Access Compliance Report Public Rights-of-Way (Curb Ramps)

Main Street: CLYDESDALE_DR		Cross Street: DORRANCE_DR		Location:	W
ADA ID: RPRK211110131519	Ramp Type: Type 4 - Parallel	Initial Pass/Fail: Fail	Overall Compliance: No	Severity Score:	32
Codes/Mitigation Info/Possible Solution			Field Measurements/Component Compliance

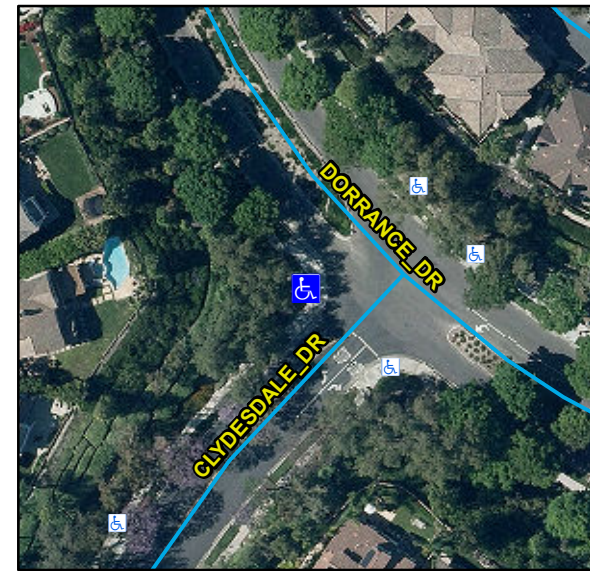
R204.3, R304.5.3, R304.3.2, STD 1115

Remove & Replace Curb Ramp With Two New Directional Ramps or Equivalent.
